Chad Wallace – (Applicant) Bruce Basden – (Owner)

SUP for Mini-warehouse Commercial Site Plan with Waivers

Basden Storage CSP

Basden Storage SUP

Site Plan Summary:

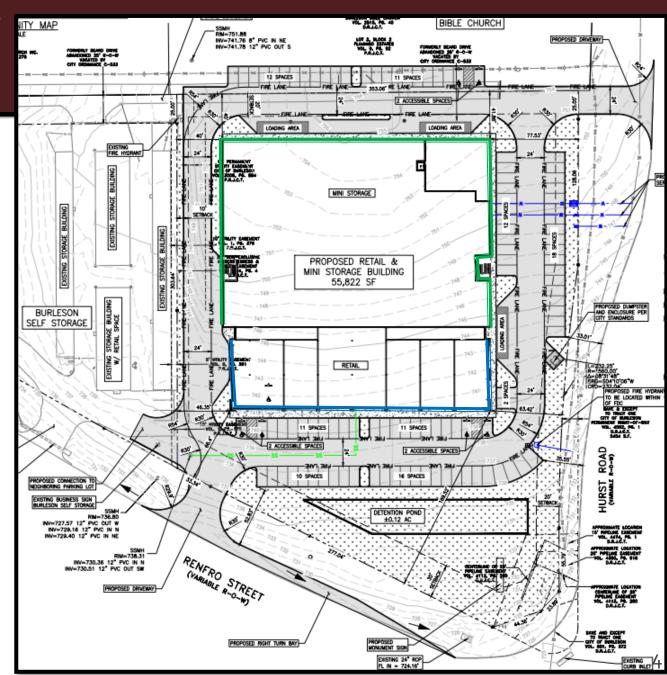
- Building footprint: 55,822sf
- Gross floor area: 153,648sf
- Height: 45 feet / Three-stories
- Use: Retail / Self-storage
 - Six retail suites (17,000sf)
 - Three levels of climate controlled selfstorage (137,000sf)
- > 11 waivers being requested
 - one warrants P&Z Recommendation
- Parking agreement

- Landscaping generally (h)
 - P&Z consideration is required when making recommendation

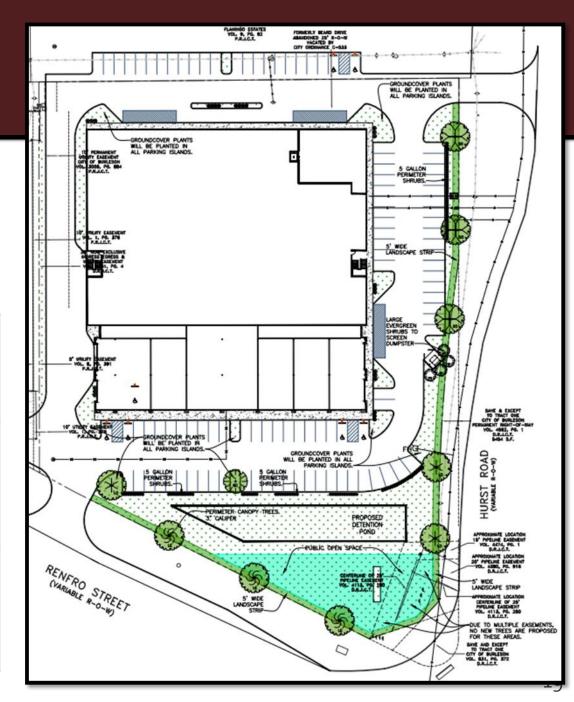
<u>Required:</u>	Grass and/or groundcovers shall not be allowed to comprise over 90 percent of any required landscape area.
<u>Provided:</u>	The landscaping plan is proposing 96% of the landscape area to be grass and/or groundcover in lieu of the required maximum of 90%.
<u>Justification:</u>	The percentage of grass and groundcover exceeds the required amount due to the reduction of trees and shrubs as a result of the sites topography.

Recommend to City Council approval of an ordinance for a specific use permit for miniwarehouse and a commercial site plan with a waiver to Section 86,103(h) (Case 23-010).
